Technical Service Bulletin

Topic	DTC P14AB00 and/or other related exhaust flap DTC's - Warning lamp evident within the DIP
Market area	Bentley: worldwide (2WBE),Hongkong-Macau (5HK)
Brand	Bentley
Transaction No.	2055664/3
Level	EH
Status	Released for publishing
Release date	Dec 10, 2025

Bentayga V8 Kovomo and Bentayga W12 TSI

Figure 1

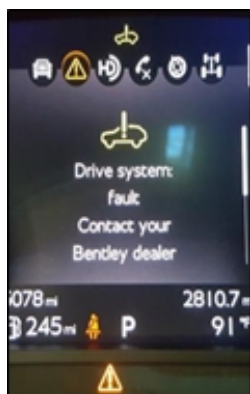
- Referring to Figure 1 - Warning lamp illuminated within the Drivers Information Panel (DIP)

- DTC P14AB00 and various DTC's evident within the Engine control modules 1 and/or 2 regarding exhaust control unit mechanical malfunctions
- Abnormal noises from the exhaust system
- This issue is applicable to both Standard and Sports exhaust systems
